16 Cold Harbour Close, Wickham, PO17 5PT

First floor rear extension. (amendments to 20/02156/HOU)

Reference: 21/01836/HOU

Rear Elevation

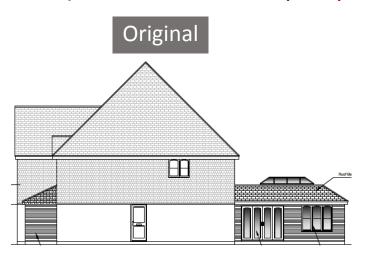
Changes proposed to rear elevation is to remove the rear 'clip' to the roof to a full gable end.

Side (East) Elevation (17 Harbour Close perspective)

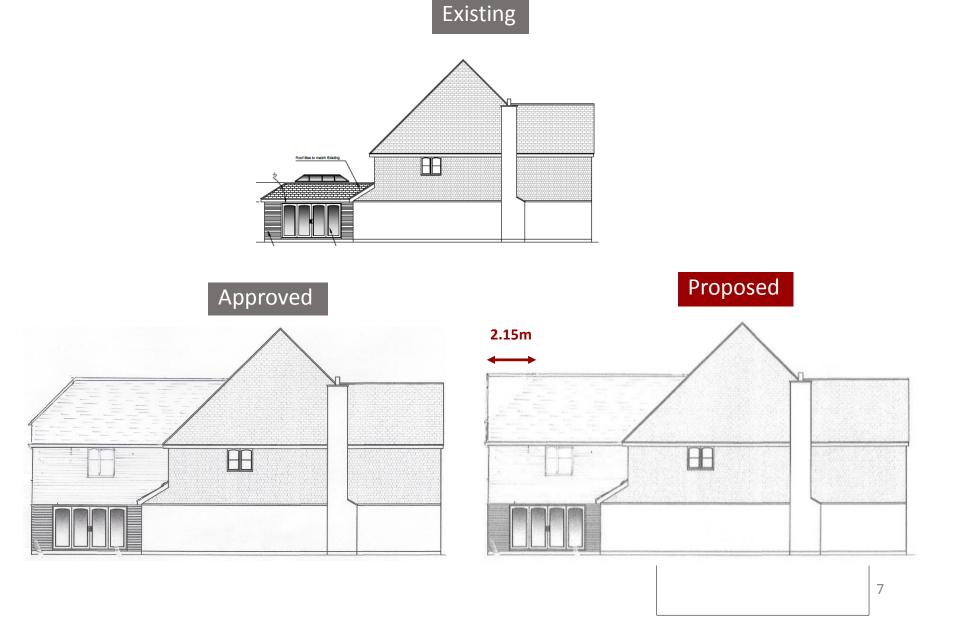
Approved First floor windows obscure-glazed, top opening only

First floor windows removed; insertion of 2 rooflights (55cm x 70cm); Roof extended to gable end.

Proposed Section

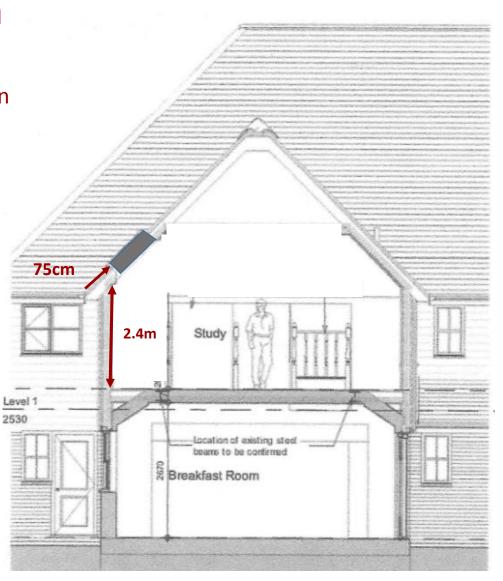
Rooflights (55cm x 70cm) set in east slope measures 2.4m above internal head height; positioned 75cm above eaves.
